TECHNICAL NOTE

Project Name	Kemnay Flood Study		
Project No.	4021839		
Document Title	Hydraulic Model Review Note		
Issue Date	21/03/25		
Issue Status	FINAL		
Prepared	Checked	Reviewed	Approved
<i>AG</i>	<i>JK</i>	<i>HB</i>	<i>HB</i>

2. Existing Scottish Water Model

Figure 3 – Subcatchments within Scottish Water model

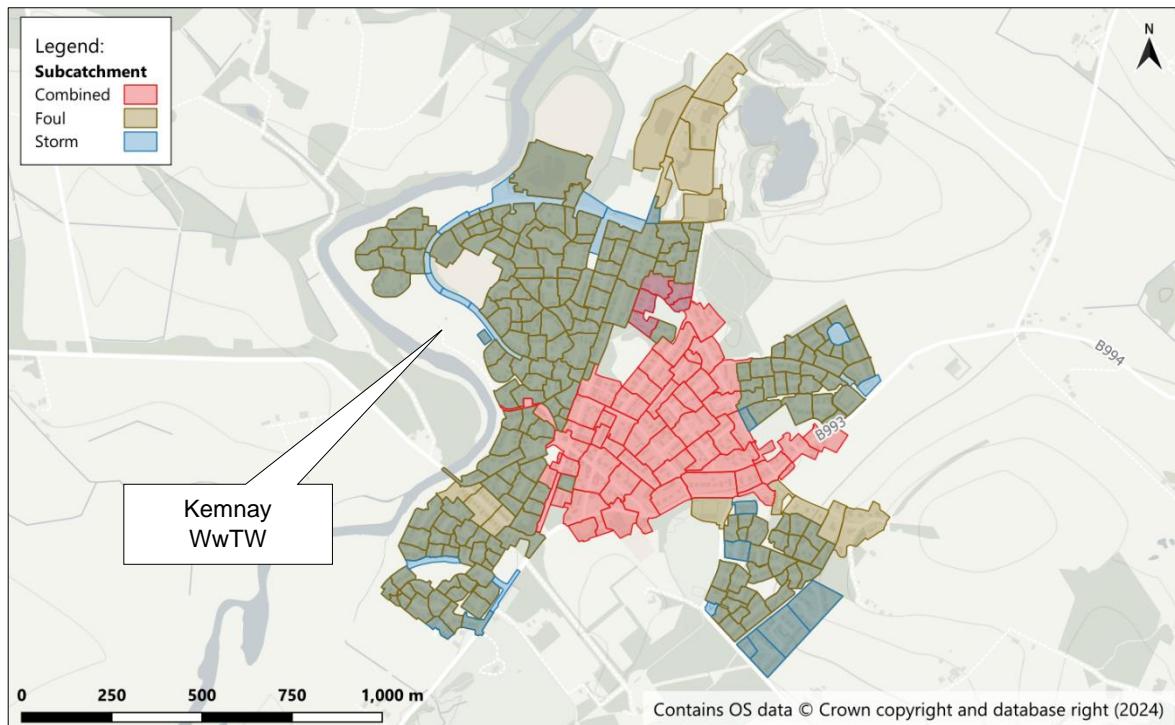
Figure 2 shows a schematic representation of the model to show how generated flows are drained across Kemnay. Figure 3 shows the extents of the subcatchments across the town. The total area of subcatchments were found to always equal the contributing area – hence, no account was made for 'additional' inflows from areas outside the defined Subcatchments (i.e., overland flows from farmland, for example). While this was acceptable for the model build drivers, this situation is not considered suitable for an adequate representation to determine potential issues related with surface water. Therefore, some modifications are required to account for surface water flows from locations outside of the subcatchments areas represented in the provided model.

1. Apply storm, greenfield and ReFH subcatchments to remaining areas where they do not currently exist in the model and assign the appropriate parameters.
2. Represent the currently missing surface water networks and ditches not currently represented in the model.

Figure 4 – Scottish Water network model extents

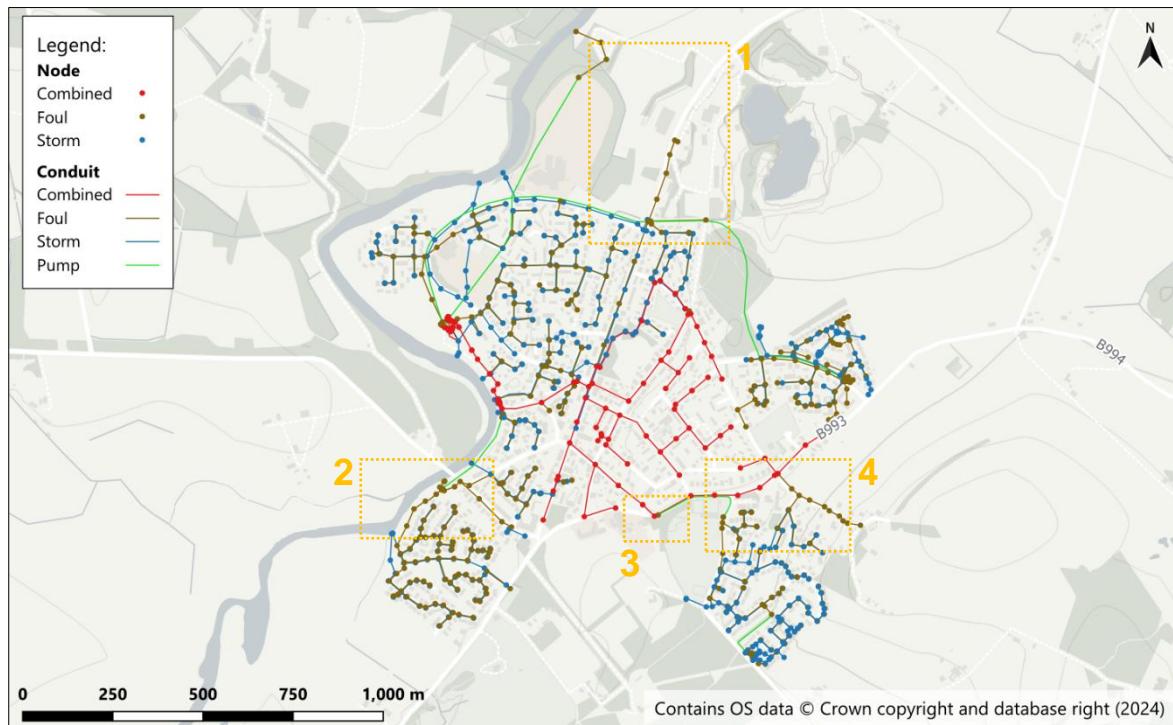
As shown in Figure 4, the sewer network covers most of Kemnay, but there are some areas where storm water networks are not included in the model:

1. Industrial estate at Aquithie Road, north of Kemnay;
2. Residential area at Riverside Road;
3. Kemnay Bowling Club at Victoria Terrace; and
4. Some properties along Parkhill.

It is understood that information about these missing networks was not available during the model build process at the time of the original model build. Areas 1 and 2 are likely served by surface water networks draining into the River Don, while areas 3 and 4 likely drain into the ditch along Victoria Terrace. The exclusion of these networks did not affect the original purpose of the model, and their absence was deemed acceptable for the intended use of the model. These should be added to the model for the Kemnay Flood Protection Study.
